APPLICATION NO.	FILING DATE	FIRST NAMED INVENTOR	ATTORNEY DOCKET NO.	CONFIRMATION NO.
10/553,583	10/17/2005	Peter Rippl	71917	4015
23872 MCGLEW & T	7590 05/28/200 UTTLE, PC	EXAMINER		
P.O. BOX 9227			CLARK, MAYA ANGELICA	
SCARBOROUGH STATION SCARBOROUGH, NY 10510-9227			ART UNIT	PAPER NUMBER
			3742	
			MAIL DATE	DELIVERY MODE
			05/28/2009	PAPER

Application No.	Applicant(s)				
	10/553,583	RIPPL, PETER				
Office Action Summary	Examiner	Art Unit				
	MAYA CLARK	3742				
The MAILING DATE of this communication app Period for Reply	ears on the cover sheet with the c	orrespondence address				
	A IC CET TO EVOIDE AMONTHA	S) OD TUUDTY (20) DAVE				
A SHORTENED STATUTORY PERIOD FOR REPLY WHICHEVER IS LONGER, FROM THE MAILING DA - Extensions of time may be available under the provisions of 37 CFR 1.13 after SIX (6) MONTHS from the mailing date of this communication. - If NO period for reply is specified above, the maximum statutory period w - Failure to reply within the set or extended period for reply will, by statute, Any reply received by the Office later than three months after the mailing earned patent term adjustment. See 37 CFR 1.704(b).	ATE OF THIS COMMUNICATION 36(a). In no even

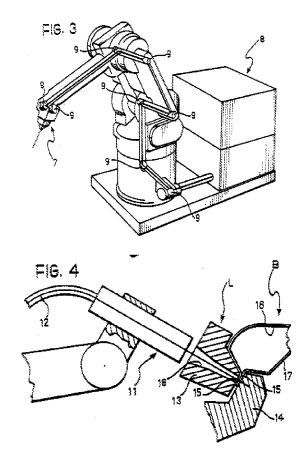
Regarding claims 1, 2, 10, 12, and 13, Alborante discloses a robot laser welding system and process for welding one or more components. The device is made up of one or more laser focusing welding heads (7-fig.3 below and 11-fig.4 below) with the plurality of the laser welding heads connected to an external laser beam source (8-fig.3 below) by means of one or more laser beam guides i.e. optical fibers (12-fig.4 below) and a conveyor line (not shown) for moving the components relative to the one or more laser heads (col.1-lines 8-23 and lines 34-54; col.2-lines 60-68; col.3-lines 7-10). This laser welding device allows for welding to be completed simultaneous thereby reducing the overall production time.

Regarding claims 7 and 18, Alborante discloses a laser focusing welding device wherein said moving means for said components is controlled according to the focal distance of the welding head (7-fig.3 above and 11-fig.4 above).
